ORIGINATION FORM

Proposed Revisions to a Standard Plans Index

Index Number: 700-040

Index Title: Cantilever Sign Structure

SHEET
1 of 5

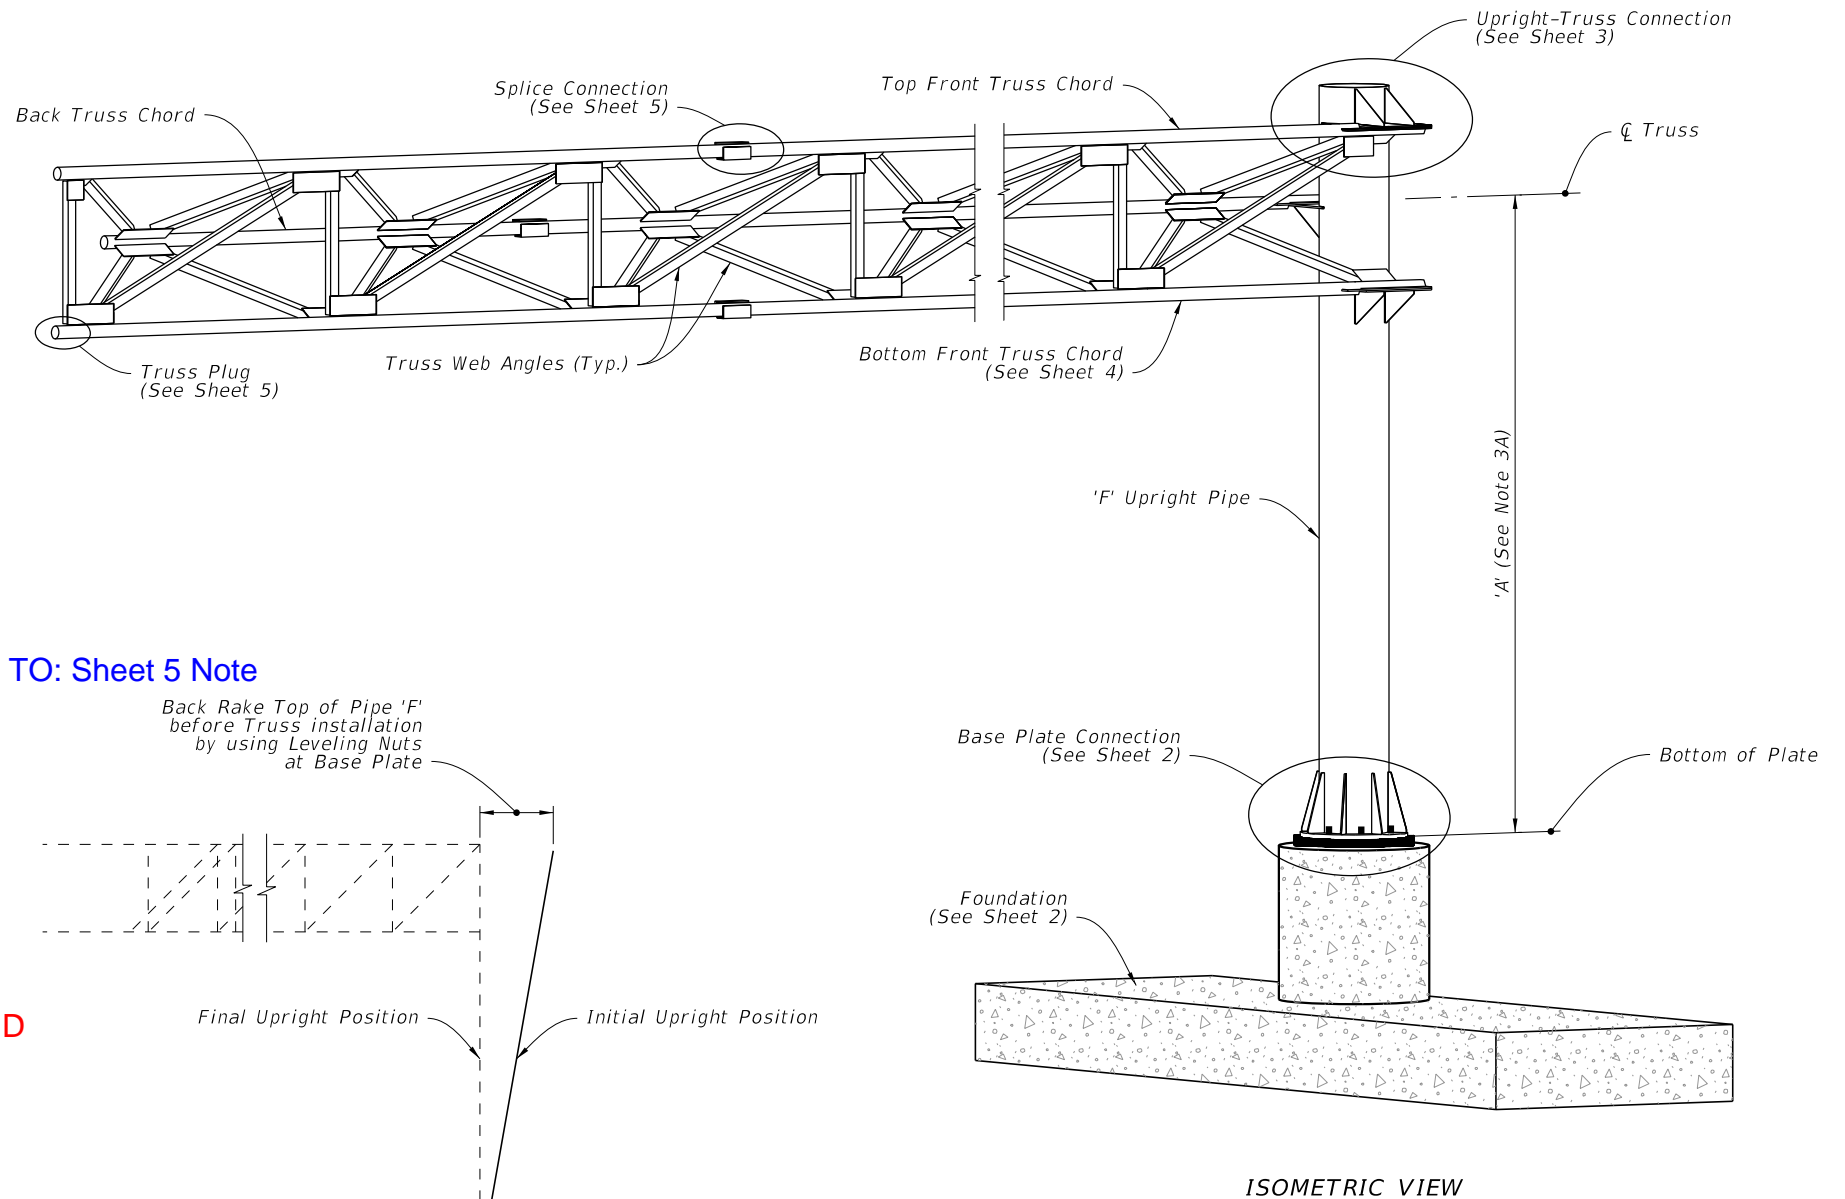
Sheet 1: Updated Notes to General Notes; Added New General Note 1 - "Meet the requirements of Specification 700."; Deleted Notes 4 through 7; Moved Note 5.B to Sheet 5 Notes; Renumbered Notes.

UPDATED: GENERAL NOTES:

ADDED NEW NOTE 1: Meet the requirements of Specification 700.

~~4. Materials:~~

DELETED

~~5. Fabrication:~~

MOVED TO: Sheet 5 Note

~~6. Coatings:~~

DELETED

~~7. Construction:~~

GENERAL COMMENT: Some material, construction, and fabrication information was deleted. Information is either already covered in Standard Specifications OR will be added to Section 700, 962 or 965 in conjunction with these revisions.

FOUNDATION

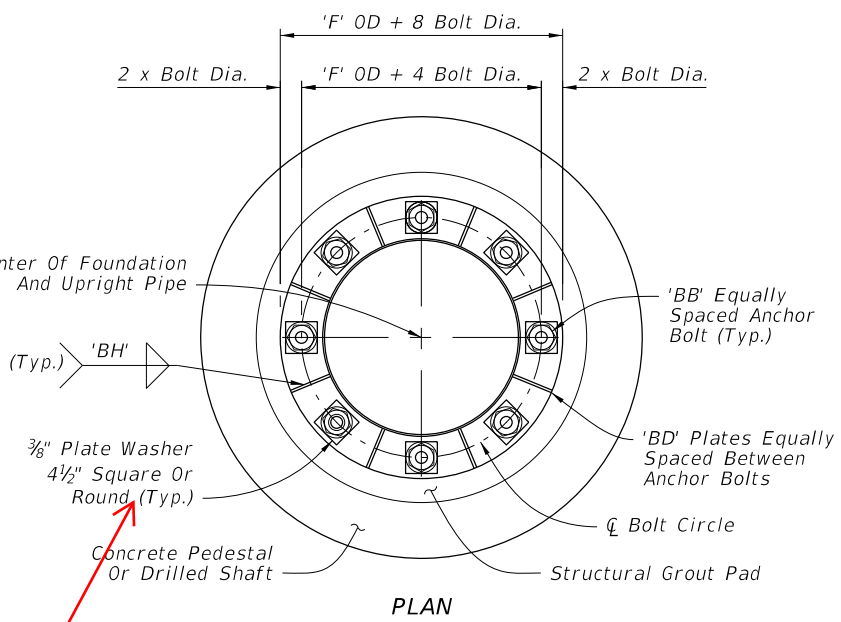
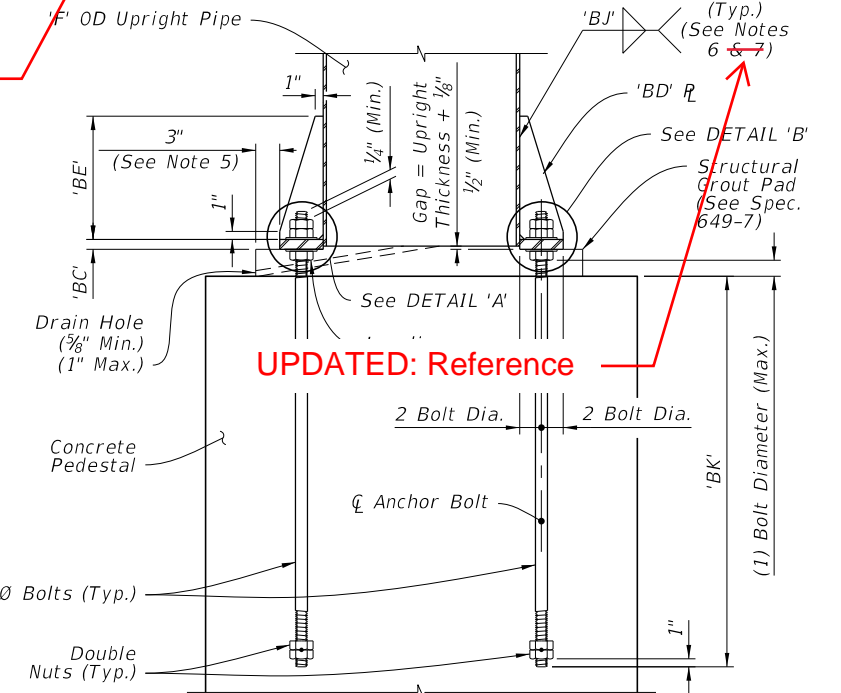
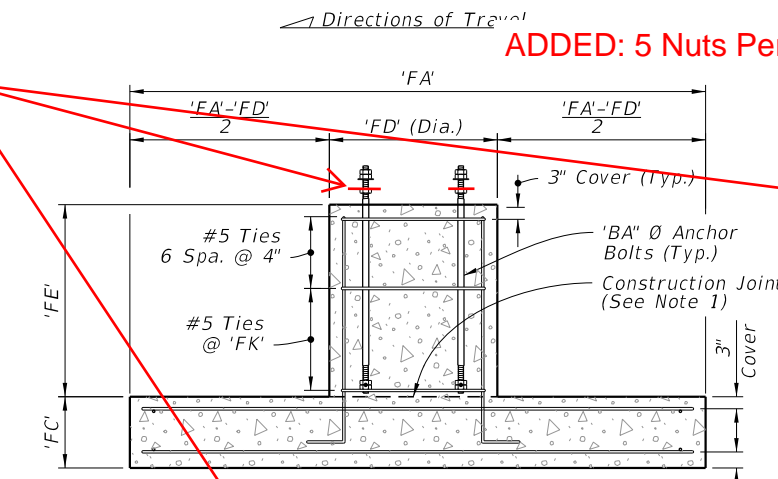
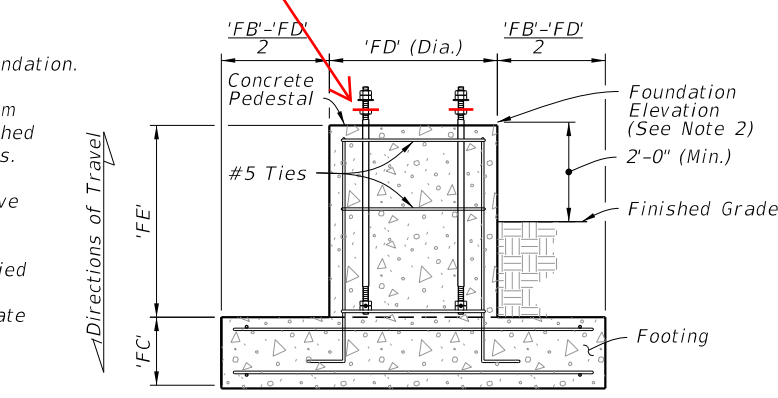
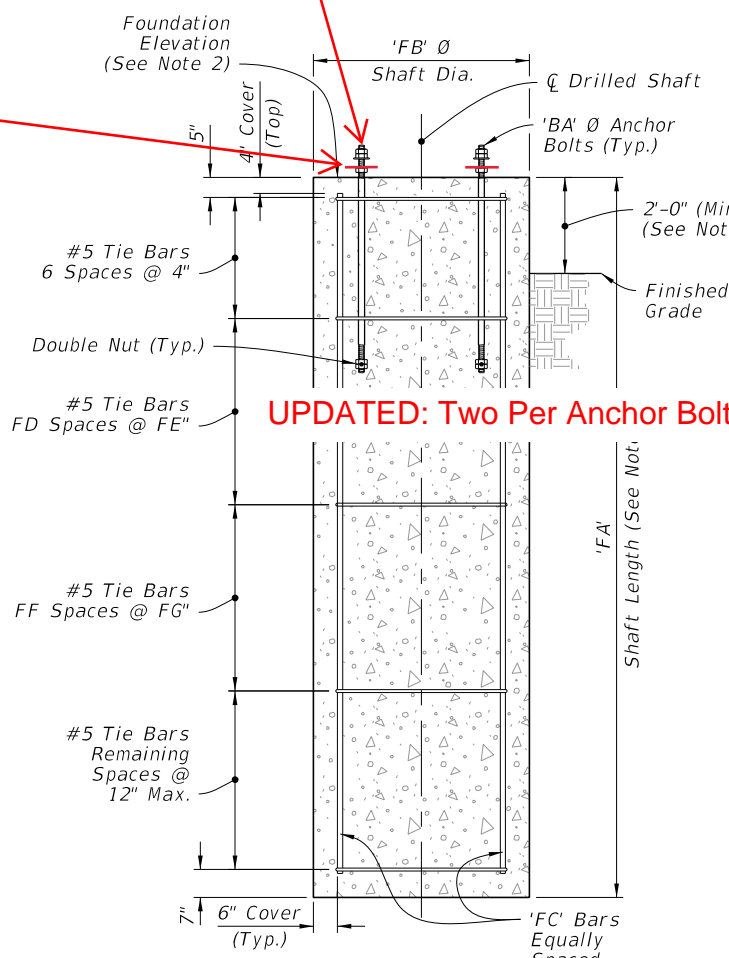
Sheet 2: Deleted Note 7 ; Added Plate Washers to the Anchor Bolts and new callout "5 Nuts Per Anchor Bolt (Typ.)"; in the FOUNDATION details; Updated the Plate Washer callout and the weld references in the BASE PLATE CONNECTION details; Added new note detailing the weld pattern of the 'BD' plates indicating that they should be welded in a star pattern.

ADDED: Washers

ADDED: 5 Nuts Per Anchor Bolt (Typ.)

UPDATED: Two Per Anchor Bolt

UPDATED: Reference

ADDED NEW NOTE: Weld plates 'BD' in a star pattern. A star pattern is one in which the plates on opposite and near opposite sides of the pole circle are successively welded in a pattern resembling a star. For an 8 plate circle with plates sequentially numbered 1 to 8, weld the plates in the following order: (1, 5, 7, 3, 8, 4, 6, 2).

DELETED

Sheet 2: New Note - This process is to help prevent residual stress buildup in base plate connection to prevent cracking.

SPLICE CONNECTION DETAIL

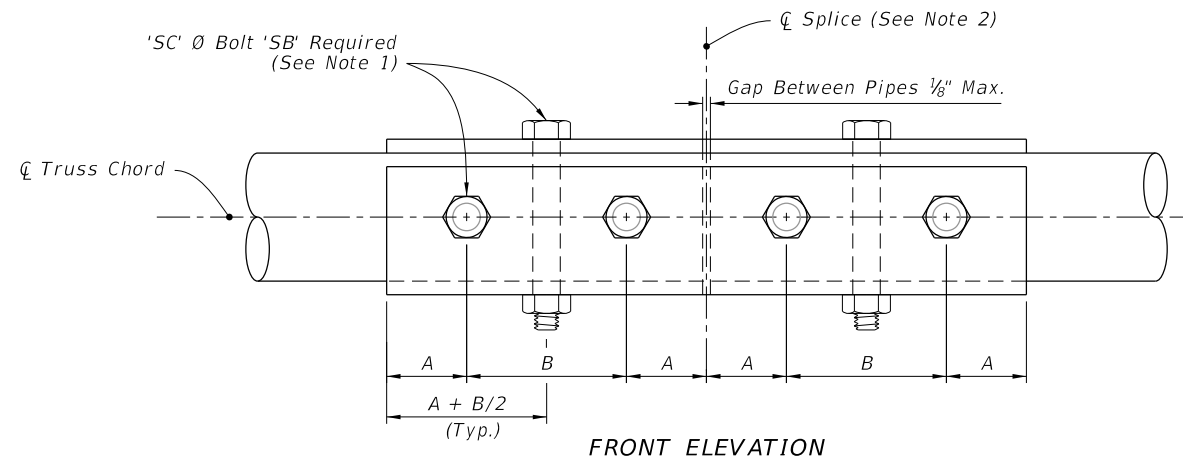
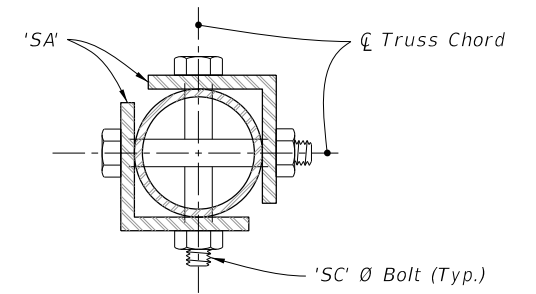
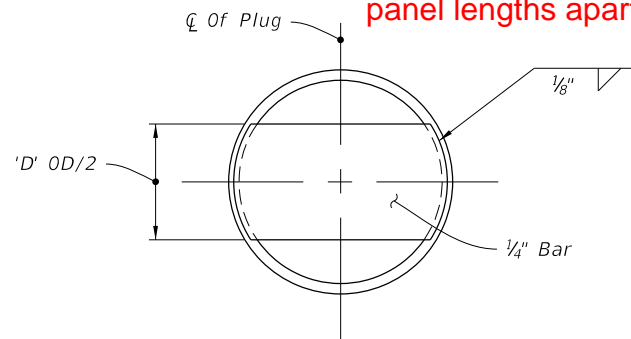
Sheet 5: Added General Note 5.B as New Note 3 - "Chord Splices: "SD" Panel from upright is the closest panel in which chord splice may be used. See Plans for CANTILEVER SIGN STRUCTURE DATA TABLE. Minimum splice spacing is two truss panel lengths apart."

ADDED NOTE 3:
 Chord Splices: "SD" Panel from upright is the closest panel in which chord splice may be used. See Plans for CANTILEVER SIGN STRUCTURE DATA TABLE. Minimum splice spacing is two truss panel lengths apart
